Project	IEEE 802.16 Broadband Wireless Access Working Group	
Title	Proposed Changes to the BWA Coexistence Working Document IEEE 802.16c-99/02r1	
Date Submitted	2000-01-11	
Source	Andy McGregor Nortel Networks PO Box 3511, Station C Ottawa, Ontario, K1Y 4H7, Canada	Voice: 613-763-7942 Fax: 613-765-5598 Email: mcgregor@nortelnetworks.com
Re:	This proposes some revisions to Working Document IEEE 802.16c-99/02r1	
Abstract	Working Document IEEE 802.16c-99/02r1 is, in part, based on text extracted from a draft Canadian standard RSS-191. The working document has some editorial errors in the text extracted and the draft Canadian standard has been revised. Based on this, some revisions to the Working Document are proposed.	
Purpose	This contribution proposes revisions to Working Document IEEE 802.16c-99/02r1.	
Notice	This document has been prepared to assist the IEEE 802.16. It is offered as a basis for discussion and is not binding on the contributing individual(s) or organization(s). The material in this document is subject to change in form and content after further study. The contributor(s) reserve(s) the right to add, amend or withdraw material contained herein

Proposed Changes to th

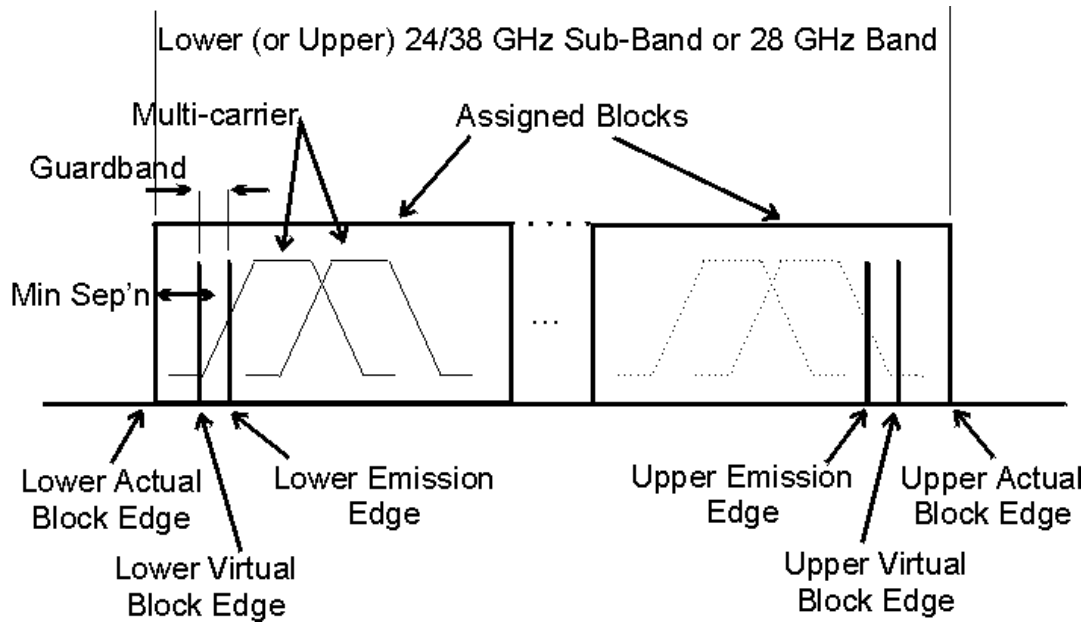
Single carrier and multi-carrier tests are to be carried out relative to a virtual block edge (defined in the following table). The virtual block edge is located within the assigned band (see diagram below). When a transmitter is designed to only operate in part of a band (e.g. because of Frequency Duplexing), the virtual block edge shall be inside the designed band of operation. The occupied bandwidth of the carrier(s) must be closer to the centre of the block than the virtual block edge. The virtual block edge is only to be used for testing and does not impact an actual implementation in any way. One virtual block edge (at frequency f_{VL}) shall be inside the lower edge of the designed or assigned band and the other virtual block edge (at frequency f_{VU}) shall be inside the upper edge of the designed or assigned band.

<u>Band</u>	<u>Minimum Separation between Actual and Virtual Block Edge</u>
<u>24 GHz</u>	<u>10 MHz</u>
<u>28 GHz</u>	<u>40 MHz</u>
<u>38 GHz</u>	<u>10 MHz</u>
